Access Compliance Report

Public Rights-of-Way

(Curb Ramps)

Intersection ID: 47903	Main Street: SPUR_RANCH_RD	Cross Street: ROUND_ROCK_RD	Location: NE
ADA ID: AA693B7BDA85	Ramp Type: PerpDiag	Initial Pass/Fail: Fail	Overall Compliance: No
Severity Score: 21.25			
Codes/Mitigation Info/Possible Solution		Field Measurements/Component Compliance

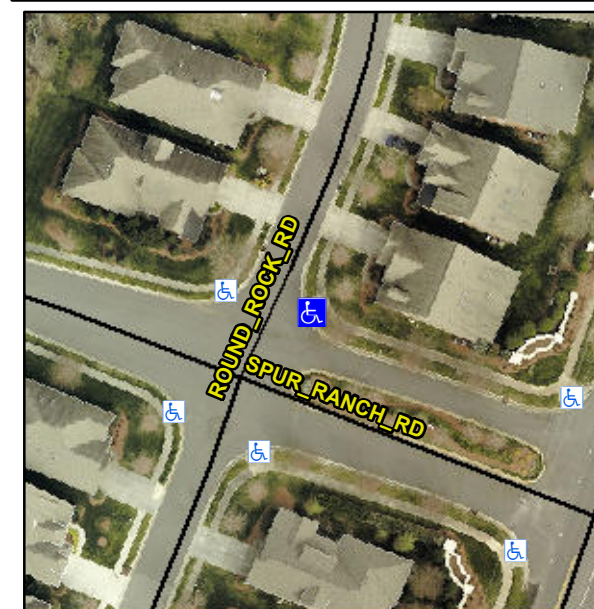
Remove & Replace Curb Ramp With Two New Directional Ramps or Equivalent.

R304.5.1, R304.5.3

Compliance	Description	Data	Compliance	Description	Data
N/A	Ramp Length (in)	136.0	Yes	Ramp Slope (%)	7.4
No	Ramp Width (in)	46.0	No	Ramp XSlope (%)	6.6
N/A	Flare Type LT	N/A	N/A	Flare Type RT	N/A
N/A	Flare Slope LT (%)	N/A	N/A	Flare Slope RT (%)	N/A
N/A	Flare Traversable LT?	N/A	N/A	Flare Traversable RT?	N/A
N/A	Landing Length (in)	N/A	N/A	DWS Provided?	N/A
N/A	Landing Width (in)	N/A	N/A	DWS Contrast?	N/A
N/A	Landing Slope (%)	N/A	N/A	DWS Length (in)	N/A
N/A	Landing X Slope (%)	N/A	N/A	DWS Full Width?	N/A
N/A	Landing Curb? (Y/N)	N/A	N/A	DWS Offset (in)	N/A
N/A	Shared Landing?	N/A			
N/A	Gutter Ponding?	N/A	N/A	Gutter Slope (%)	N/A
N/A	Gutter Lip Ht (in)	N/A	N/A	Gutter X Slope (%)	N/A
N/A	Painted X Walk1?	No	N/A	Painted X Walk2?	No
	X Walk 1 Direction	To NW		X Walk 2 Direction	To SW
N/A	X Walk 1 Width (in)	N/A	N/A	X Walk 2 Width (in)	N/A
	X Walk 1 Slope (%)	1.8		X Walk 2 Slope (%)	2.3
	X Walk 1 X Slope (%)	3.8		X Walk 2 X Slope (%)	1.5
